Product Change Notification: PCN-22-147467

DEUTSCH DT04-12P (Keys: A,B,C,D) Flanged Receptacle Housing. PCN Clarification for E-20-009825 and E-21-004924

DEUTSCH DT04 12 Position Receptacle Connector - PCN :E-21-004924 (Extension of PCN :E-20-009825)

Product Change Notification: E-20-009825

Scope of Work

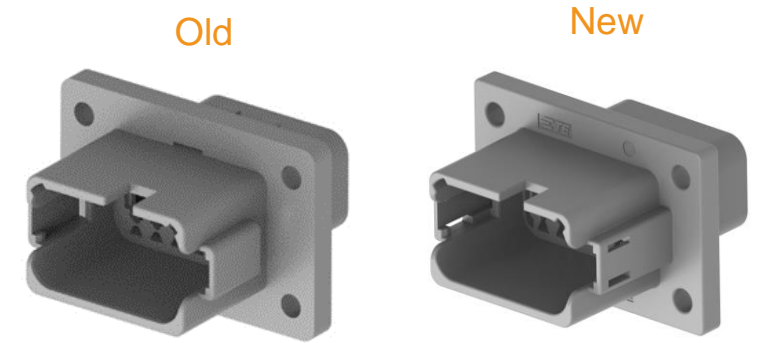
- TE Connectivity will be replacing the DT04-12P housing with welded flange design by a single piece housing with flange design.

Form Change

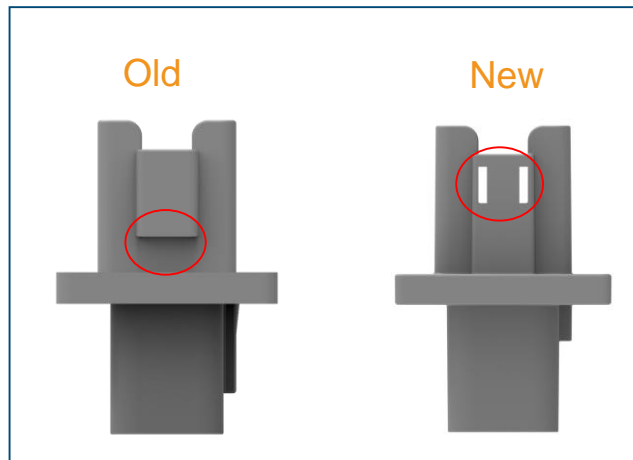
- Change in Form - two slots on the new design for tool release that are not functional

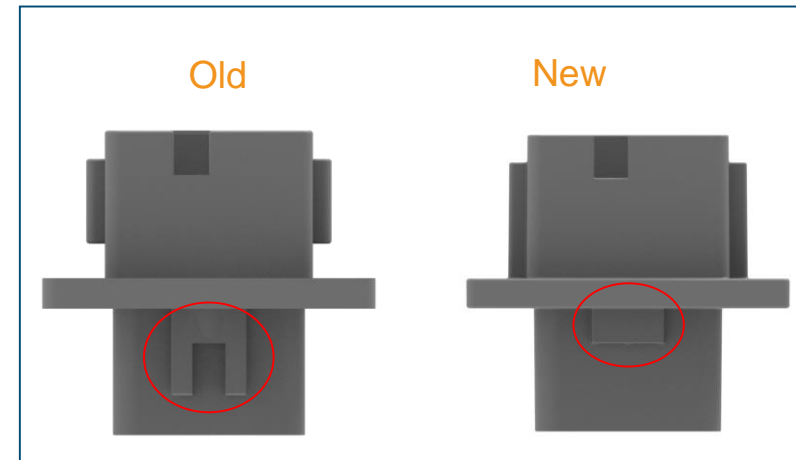
- Change in Form – Dove tail feature which was not functional is replaced by simple feature to maintain the poke yoke design

DT04-12PC-BL12 - BEFORE

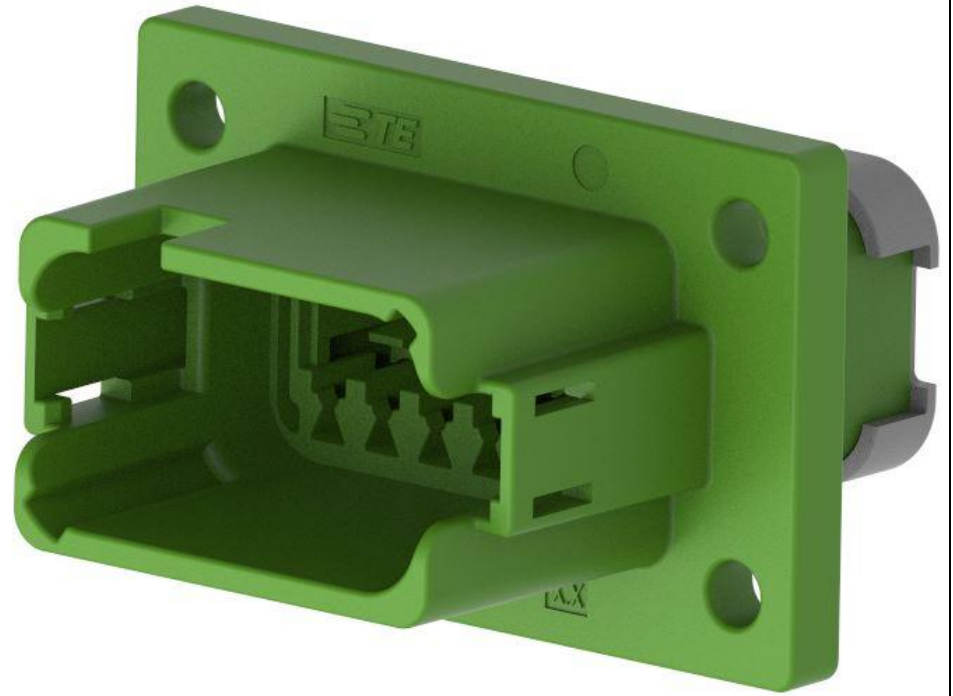
The Industrial and Commercial Transportation business unit of TE Connectivity is making a change to the DT12pin flanged receptacle housing. The mounting flange will be an integrated feature instead of ultrasonically welded onto the housing for the part number(s) listed below. These PNs are TE proprietary designs, therefore considered catalog/general market product. PPAP and/or sample requests must be submitted within 14 days of PCN submission via ict-ppap-request@te.com or ePPAP system. Submission will not occur without request. If PPAP requested, disposition response is required within 14 days of submit date or it will be considered approved. Product drawing(s) are affected. PCN for left out affected DT products. Updated Estimated First Ship Date For Changed Part as mentioned in this PCN is also applicable for PCN :E-20-009825
